SAFETY ADVISORY # 16-261

Bullet and Passport AC Wiring

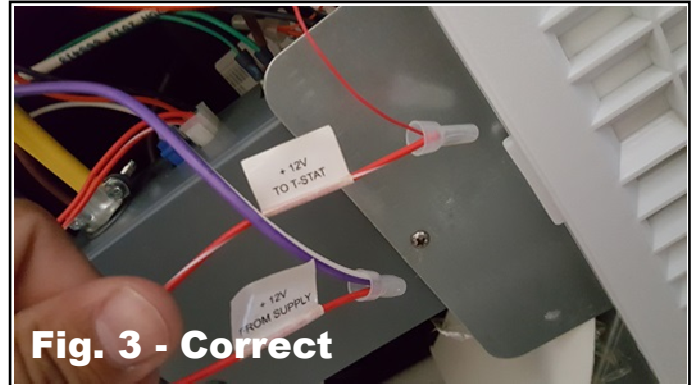
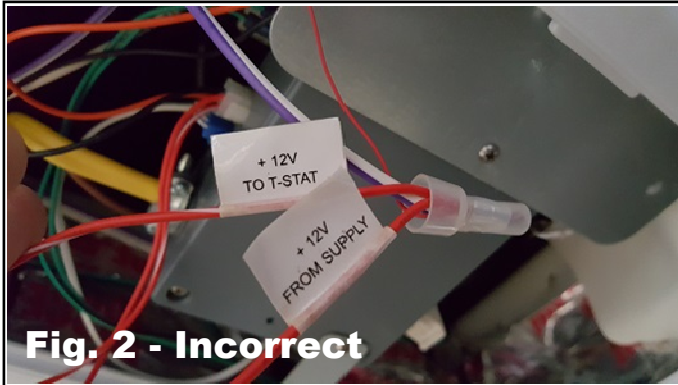
Keystone RV Company is conducting a voluntary RECALL notification campaign in accordance with the National Traffic and Motor Vehicle Safety Act. It has been decided the vehicles in this recall population may have wiring at the air conditioner that was not installed according to the air conditioner manufacturer's instructions. If the thermostat wires short together, there is an increased risk of damage or fire to the unit.

Remove bell cap or twist on connector where the positive wires that are tied together, Fig. 2, reconnect as indicated, Fig. 3.

Verify all connections are solid, no exposed bare wires.
